Extract from Pre-application advice note - PRE/2022/009 from Haringey

Revisions: A 07.12.2022 Minor amendments B 07.12.2022 Text altered C 27.02.2023 Clarifying text added D 28.02.2023 Text amended	
For planning	
FER 215	Proposed block plan and sections
Scale 1:250 @ A3	Garage site on Ferrestone Road N8 7BX
Sept 2022	
Appleton Weiner 19 Wallace Road London N1 2PG Telephone 020 7253 8387 ALL DIMENSIONS TO BE CHECKED ON SITE. DISCREPANCIES TO BE REFERRED TO APPLETON WEINER. DO NOT SCALE OFF THIS DRAWING. ALL DRAWINGS RETAIN APPLETON WEINER COPYRIGHT ©

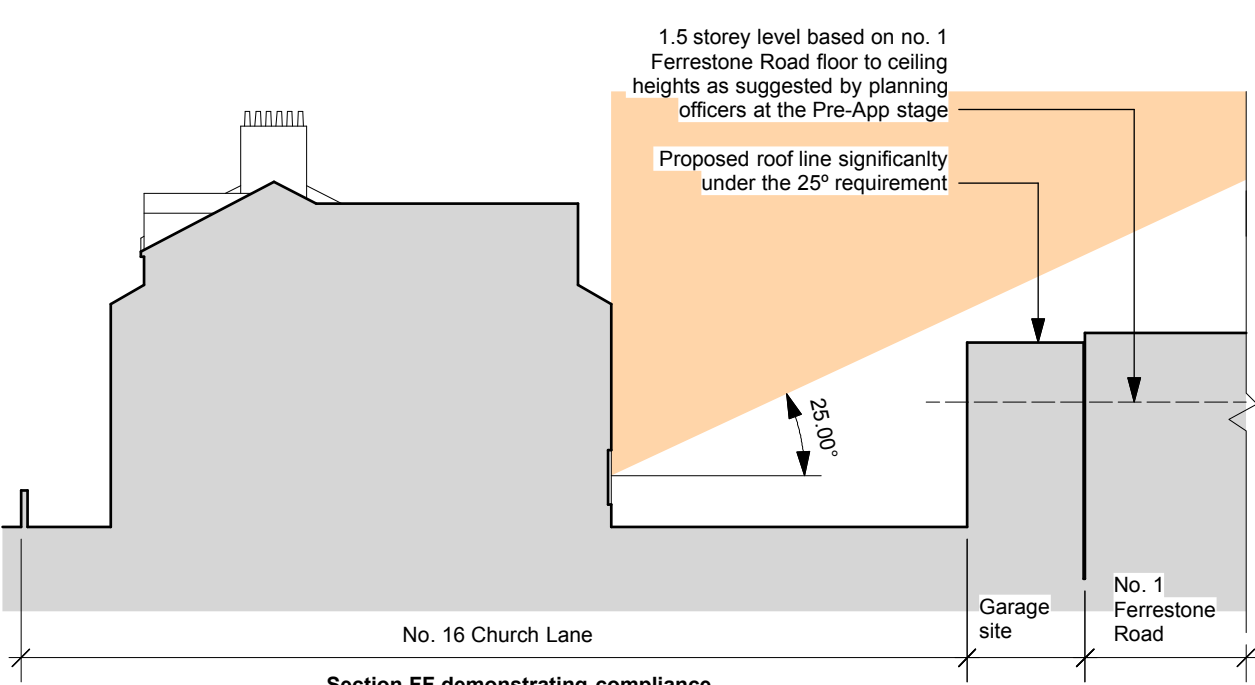
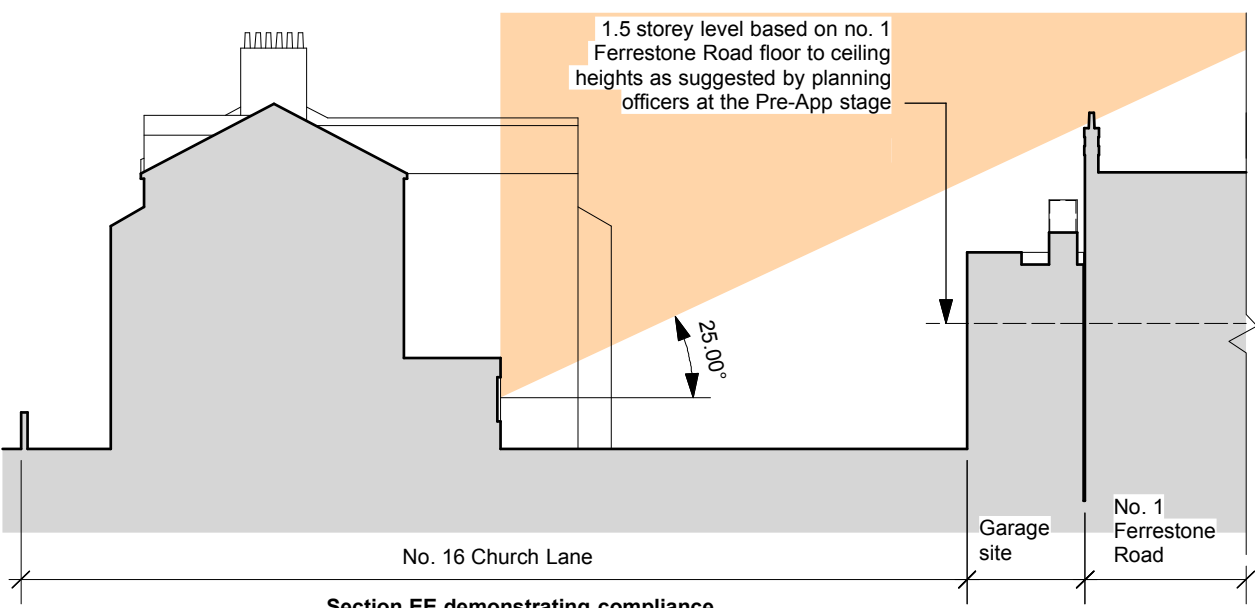
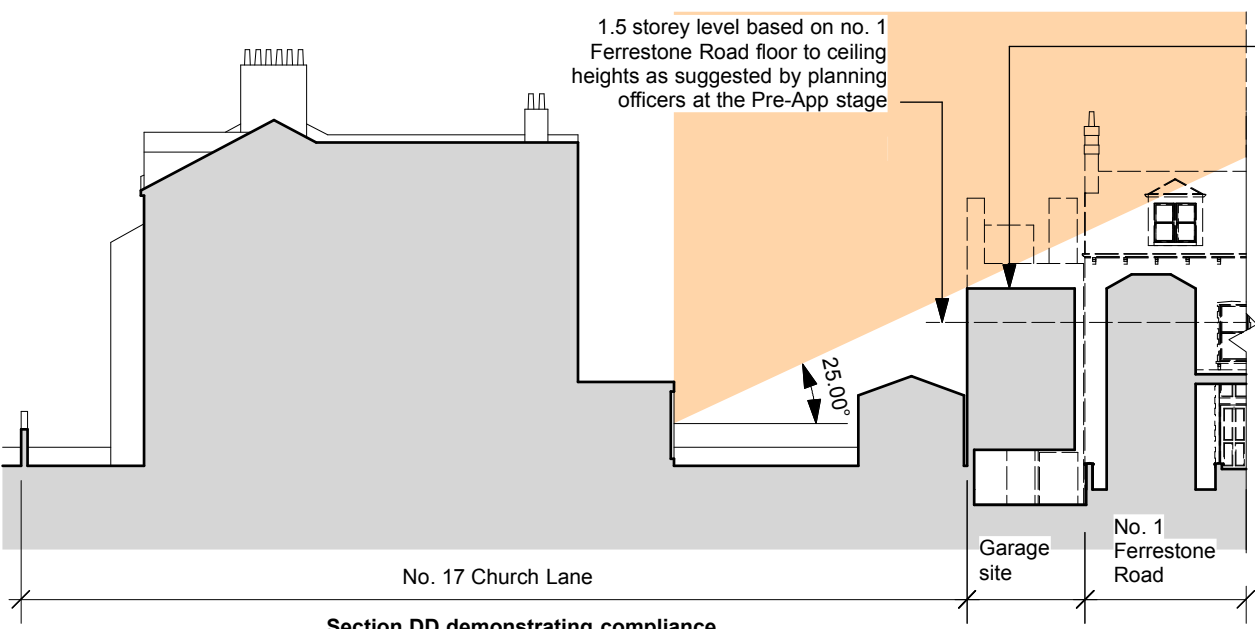
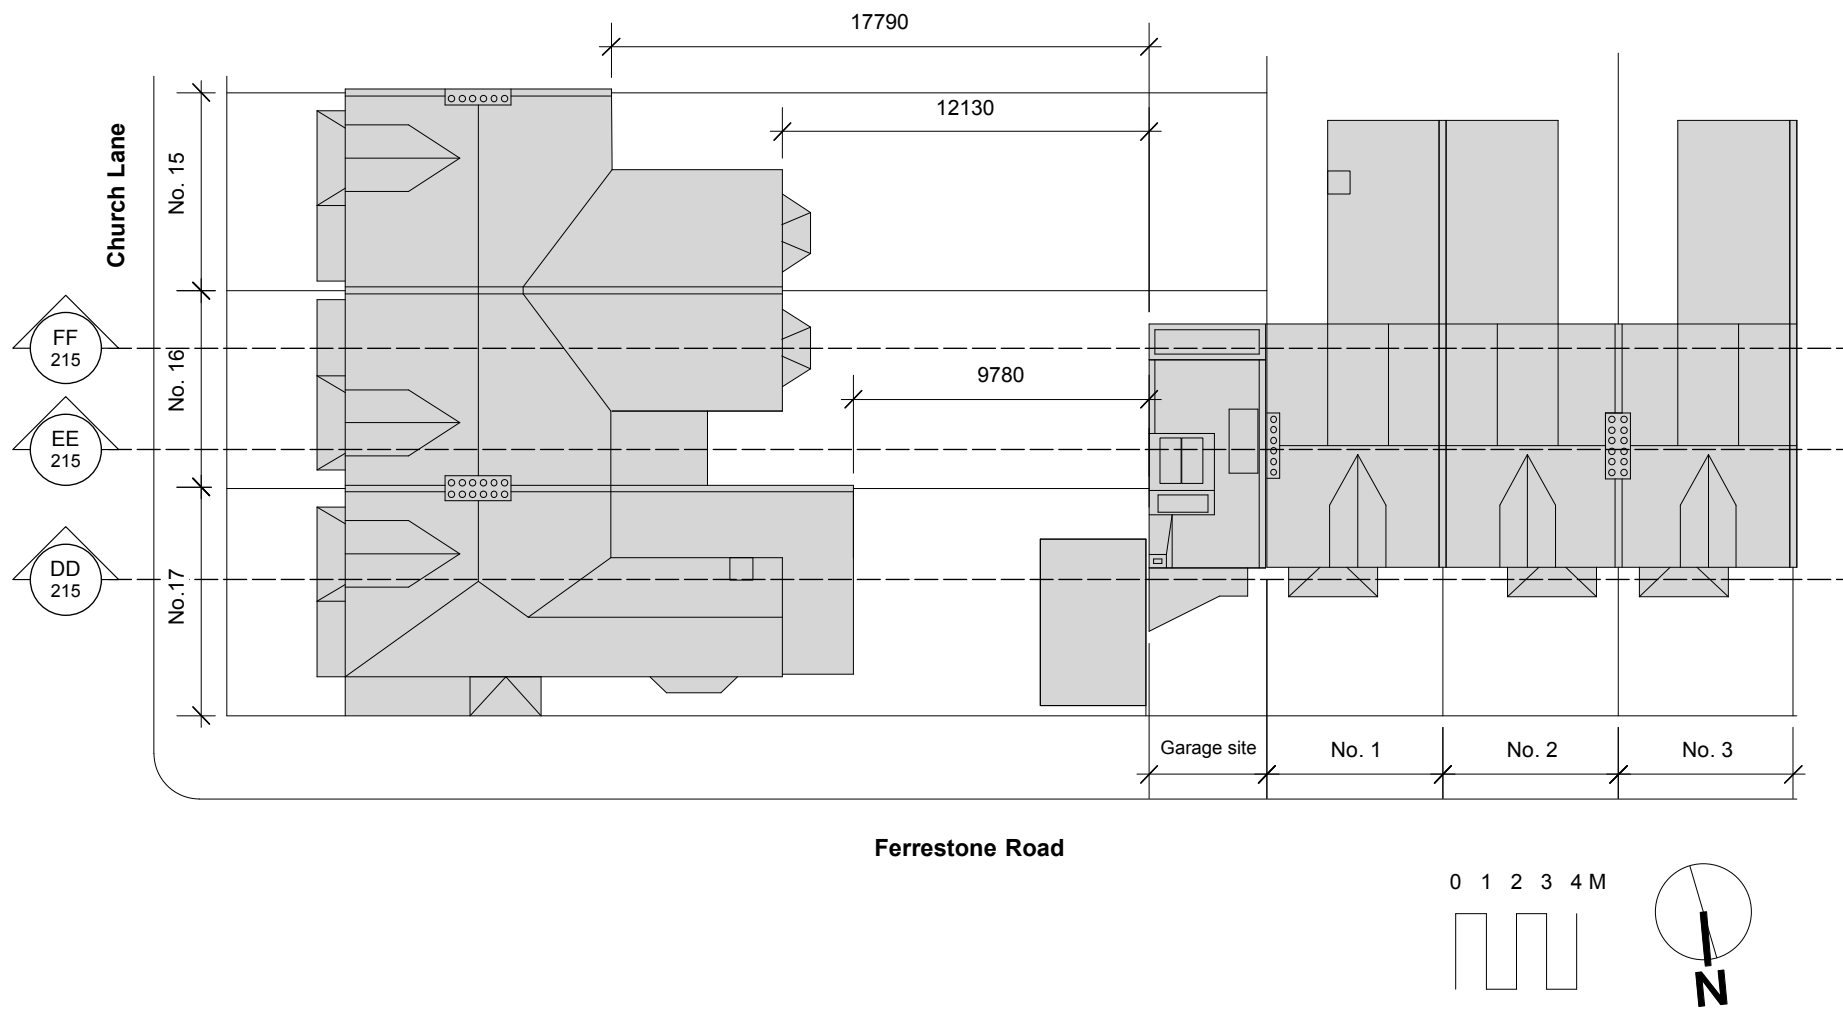
"A building (of single-storey up to 1.5 storeys (above ground level) is likely to be acceptable, subject to the roofline not being higher than a 25-degree line from the rear windows of 16 and 17 Church Lane (on section drawings)."

Architect's response:
The proposed section drawings clearly demonstrate compliance with this requirement and we, therefore, cordially request the taller building proposal be duly supported on its merits by planning officers.

Building shown dotted is beyond the section cut. The development sits below the 25° line at this section cut
